WELL API NO. 30-025-36731
5. Indicate Type of Lease STATE <input checked="" type="checkbox"/> FEE <input type="checkbox"/>
6. State Oil & Gas Lease No.
7. Lease Name or Unit Agreement Name: Triple X 6 State
8. Well Number 1
9. OGRID Number 16696
10. Pool name or Wildcat Triple X Delaware
11. Elevation (Show whether DR, RKB, RT, GR, etc.) 3642' GR
Pit or Below-grade Tank Application <input type="checkbox"/> or Closure <input type="checkbox"/> Pit type _____ Depth to Groundwater _____ Distance from nearest fresh water well _____ Distance from nearest surface water _____ Pit Liner Thickness: _____ mil Below-Grade Tank: Volume _____ bbls; Construction Material _____

SUNDRY NOTICES AND REPORTS ON WELLS

OXY USA Inc. - Proposed
Triple X 6 State #1
API No. 30-025-36731

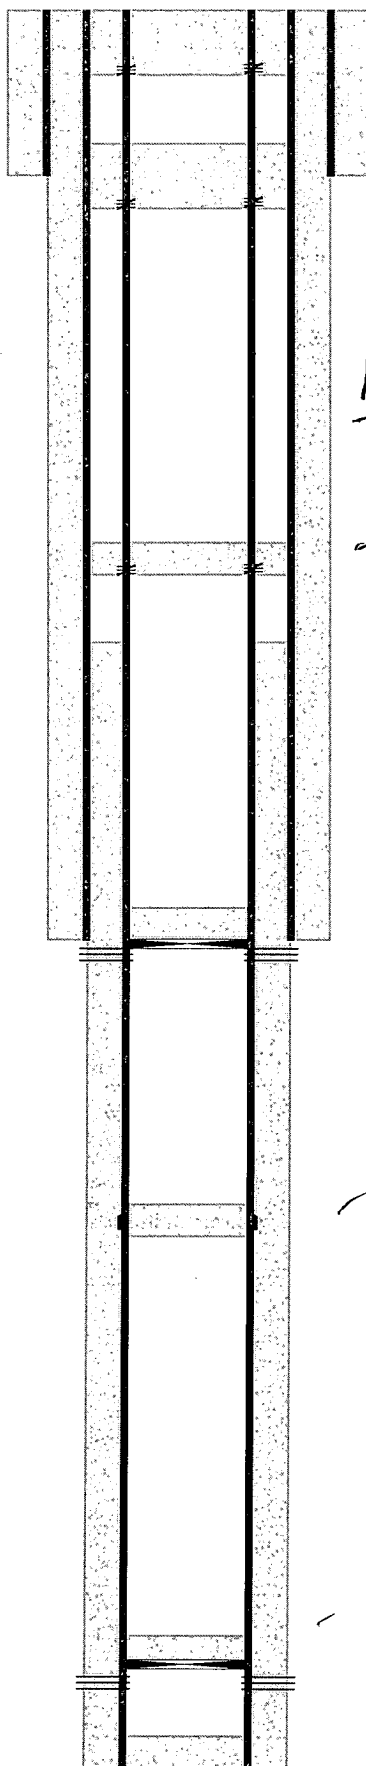
~~4B~~ 4A Perf @ 2950' sqz 40 sx cmt 2850' WOC-Tag → Perf @ 50 40sx cmt 1150 - WOC-Tag

40sx @ 1150' - 1050 WOC-TAG

Perf @ 1150
